Subject: Byron Station Units 1 and 2  
Braidwood Station Units 1 and 2  
Safety-Related D.C. System  
Additional Information  
NRC Docket Nos. 50-454/455 and 50-456/457

ATTACHMENT A  
RESPONSE TO REQUEST FOR ADDITIONAL INFORMATION  
SYSTEM-RELATED DC SYSTEM  
BYRON/BRAIDWOOD STATIONS, UNITS 1 AND 2

Figure 1

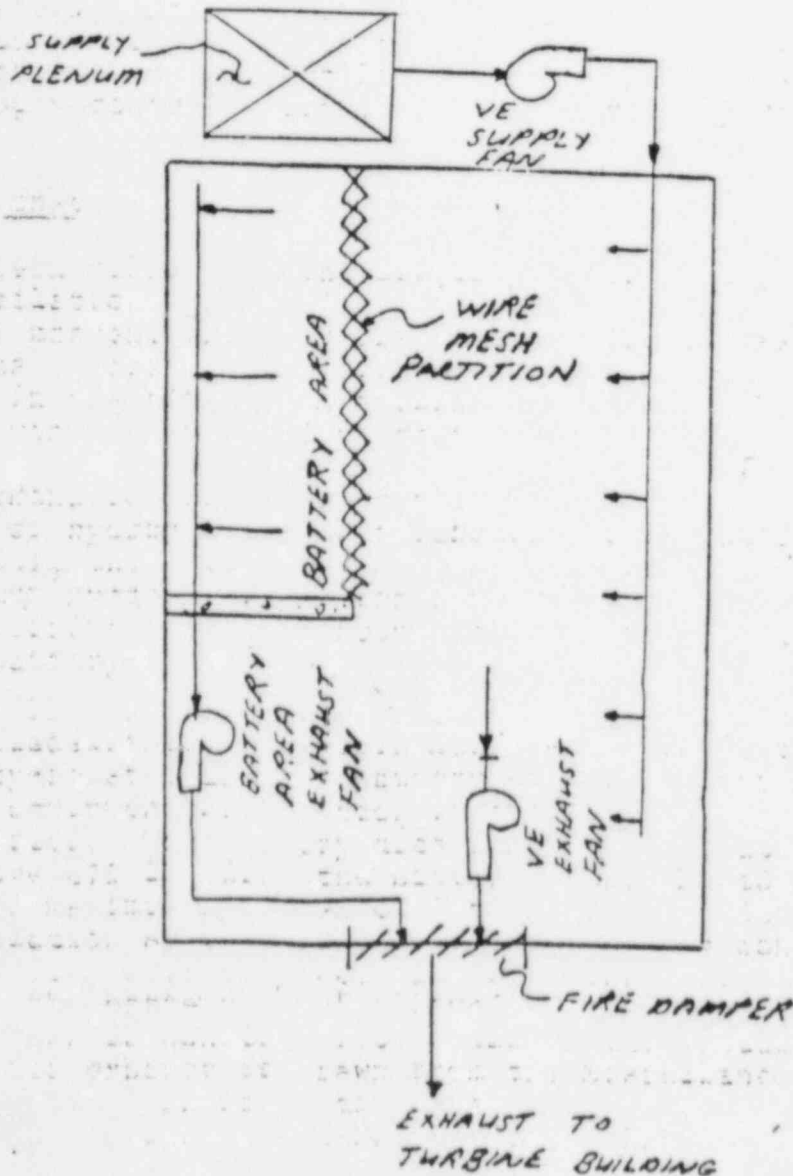
We note that in Amendment 2 to the Fire Protection Report Figure 2.3-8 Sheet 1, the applicant removed the wall between the redundant 125 volt safety-related battery divisions and other equipment in the miscellaneous electrical equipment rooms and replaced the wall with a wire fence. The present ventilation system for the battery area may not be adequate to remove hydrogen accumulation resulting from battery charging because of the much greater area now served by the ventilation exhaust system and because the new area may contain some dead spaces at the ceiling. Therefore, the applicant shall demonstrate through analysis and/or testing that the present ventilation system, including the air supply and exhaust fans in the battery area, will maintain sufficient continuous ventilation of the battery areas to limit the hydrogen concentration to 2%, as previously stated in the FSAR.

The determination of the amount of ventilation required for dilution of hydrogen gas is a function of the amount of hydrogen evolved from the batteries, and is not a function of the volume of the room. The maximum hydrogen evolution rate was based on a "runaway" charger forcing its rated output current through the fully charged battery.

Figure 1 illustrates the equipment arrangement and air flow for the Miscellaneous Electric Equipment Room ventilation system. The safety-related 125V DC Battery Area is a part of the Miscellaneous Electric Equipment Room, which is enclosed by a three-hour fire-rated barrier. The battery area exhaust ventilation system will remove 475 CFM from the battery area.

All of the makeup air for the battery area exhaust is drawn from the Miscellaneous Electric Equipment Room. In order to purge (i.e., sweep) the total volume of the battery area, the exhaust duct is located adjacent to the wall opposite the wire mesh partition. The exhaust ductwork is located at the highest practical point in the room (i.e., immediately under the intermediate roof structural steel) and extends over the entire length of the rear battery rack.

Based on the calculated maximum hydrogen evolution rate (as defined above), the ventilation system will limit the hydrogen concentration in the battery area to 1.44%; 28% less than the "2% of the total volume of the battery area" allowed by IEEE Standard 484-1981. Even if it is assumed that a fraction of the hydrogen gas (say 30%) escapes to the Miscellaneous Electric Equipment Room, the maximum concentration of hydrogen in either room is 1.44%.
